MONTICELLO NUCLEAR GENERATING PLANT
Docket No. 50-263 License No. DPR-22

License Amendment Request Dated October 15, 1975

PROPOSED CHANGE TO TECHNICAL SPECIFICATIONS APPENDIX A, OF PROVISIONAL
OPERATING LICENSE DPR-22

Specification and Bases 3.8/4.8F-Environmental Monitoring Program

Figure 4.8.1

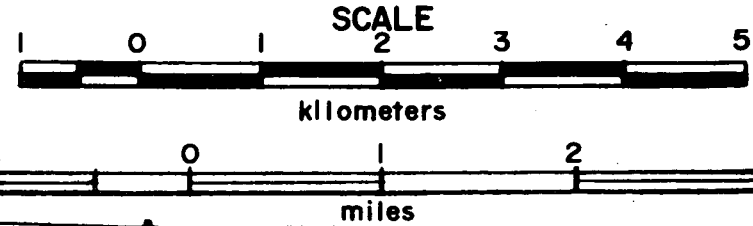
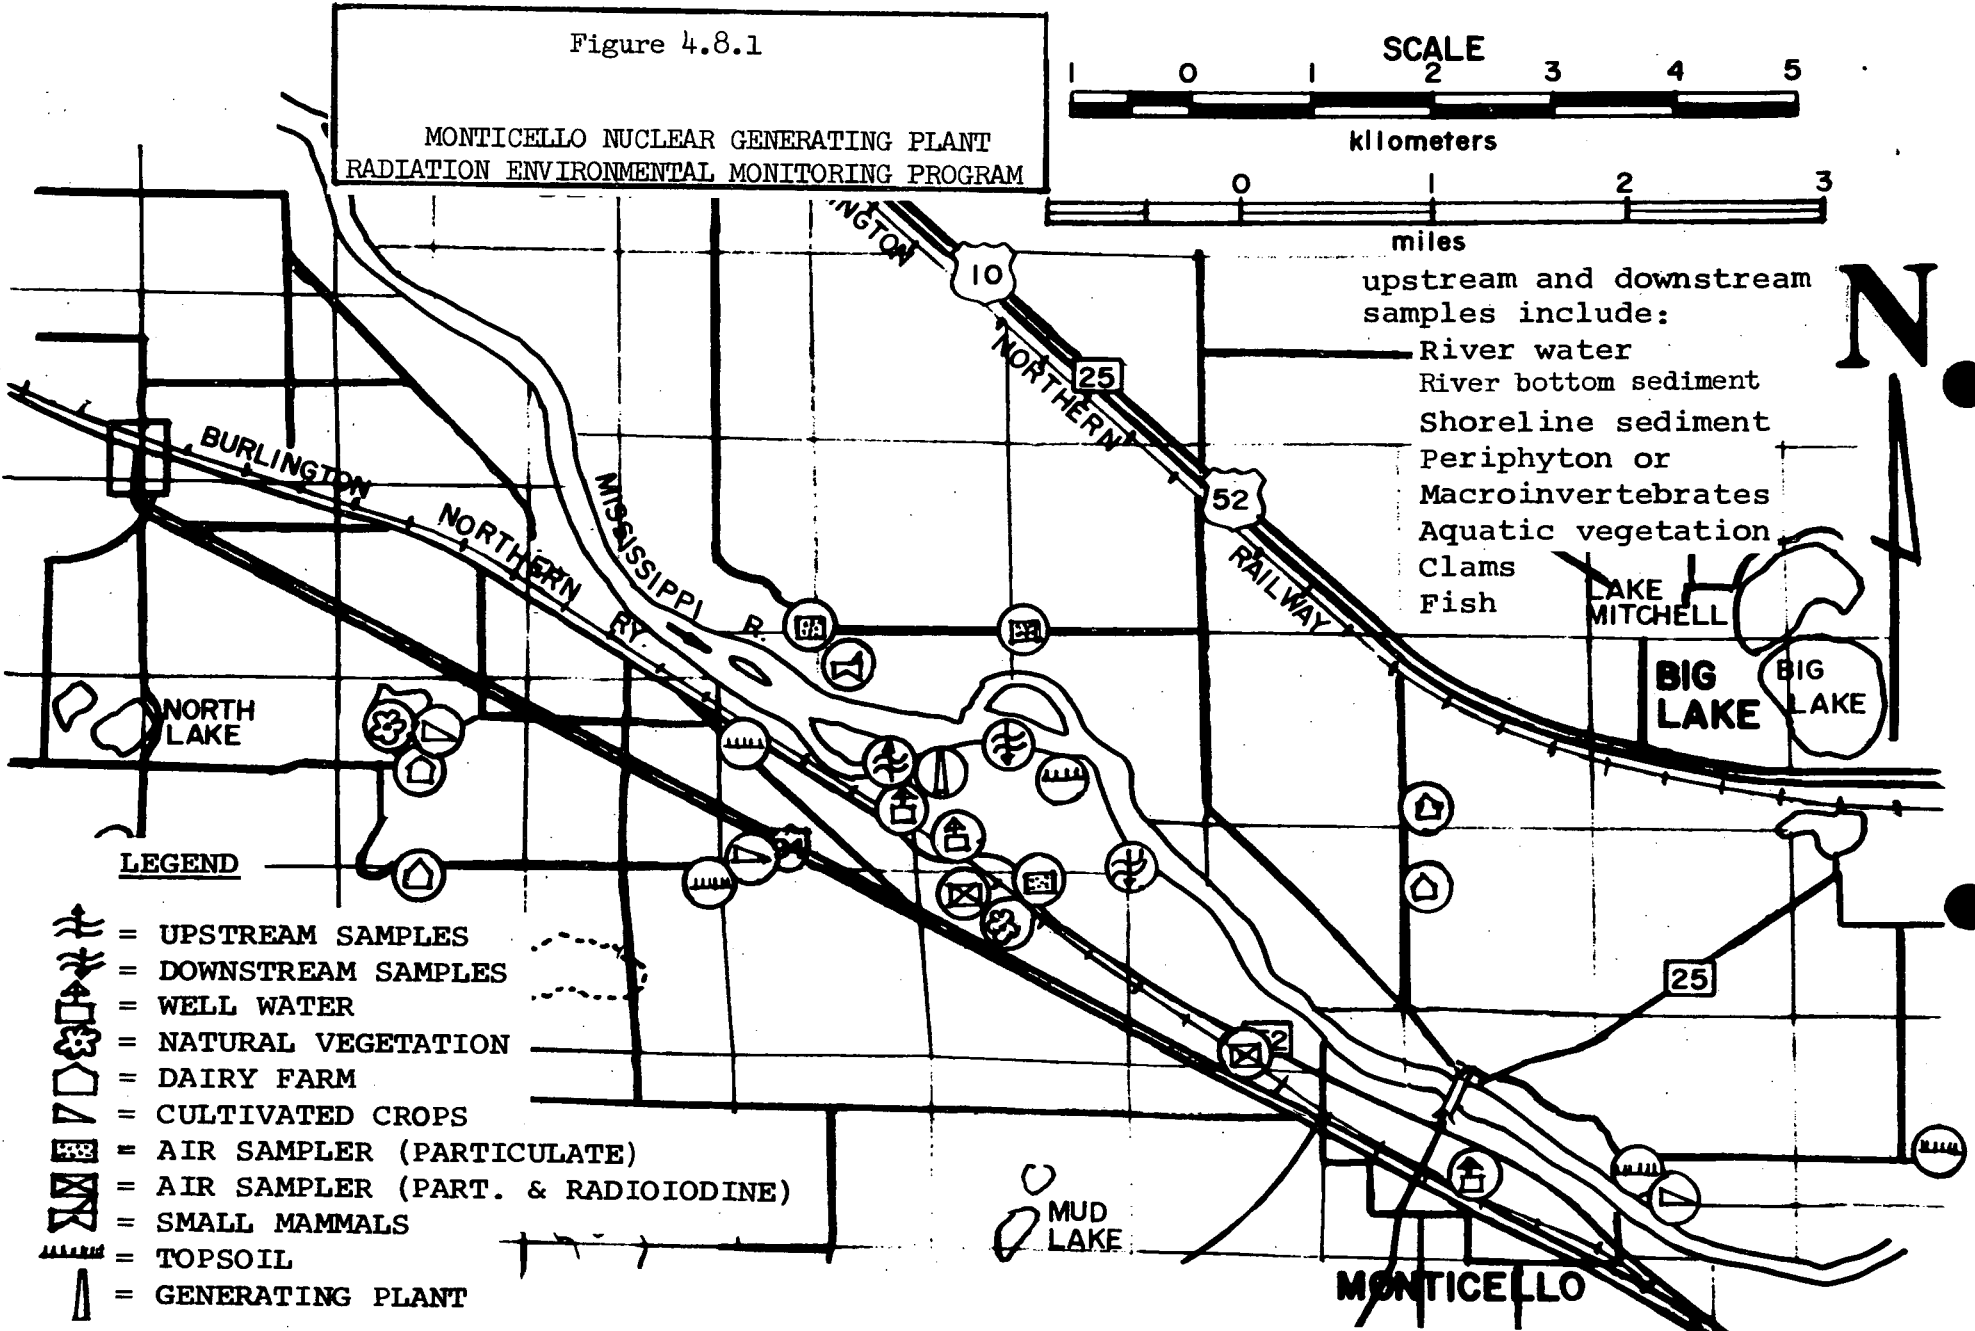
Replace Table 4.8.1, Sample Collection and Analysis, Monticello Nuclear Plant Environmental Monitoring Program with the proposed Table 4.8.1 contained in Exhibit B. Add Figures 4.8.1 and 4.8.2 and replace page 179B, 3.8/4.8 Bases, as contained in Exhibit B.
